SECTION 4.56 APPLICATION TO MODIFY DA-826/2020 | 149-163 MILTON STREET, ASHBURY

This letter has been prepared by Urbis Ltd on behalf of Coronation Property (the Applicant) in support of a section 4.56 application to modify DA-826/2020 pertaining to land at 149-163 Milton Street, Ashbury (the site).

This modification application seeks approval for the following amendments:

Picture 1 Approved Ground Floor Stormwater Design

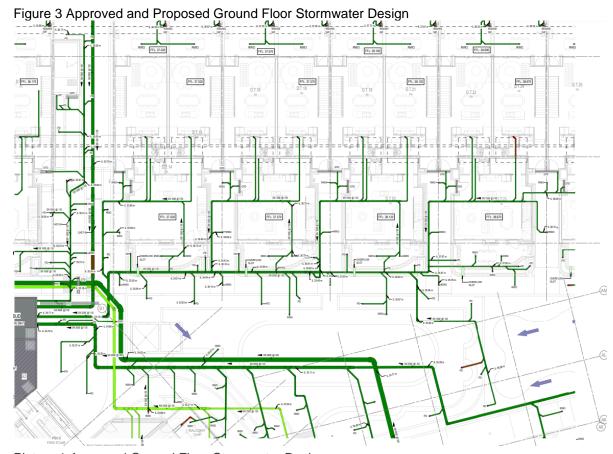
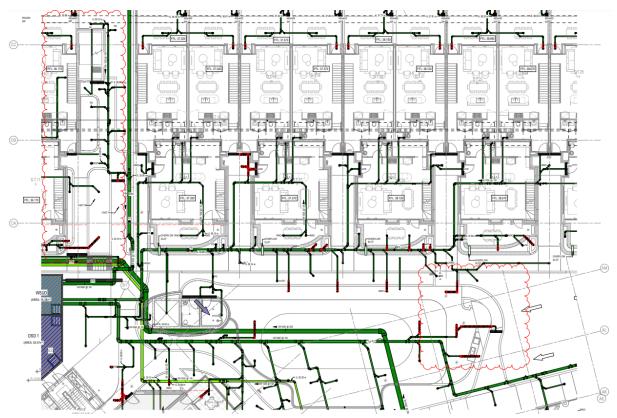
This Section 4.56 application seeks development consent to amend DA-826/2020 to remove the requirement to construct the originally proposed groundwater drainage system consisting of swales along the eastern site boundary and an associated drainage system.

Following approval of the original DA, further geotechnical investigations have been undertaken which have identified that the anticipated volume of groundwater during the operational phase of the development is very minor. Subsequently, it has been determined that the existing basement perimeter drainage system is sufficient for the proposed development, eliminating the need for a separate groundwater drainage system.

Additionally, this modification application proposes minor amendments to the layout of the stormwater drainage design, as shown in Figure 3. These proposed changes will not result in any significant impacts to the overall functioning of the stormwater drainage system.

Picture 2 Proposed Ground Floor Stormwater Design
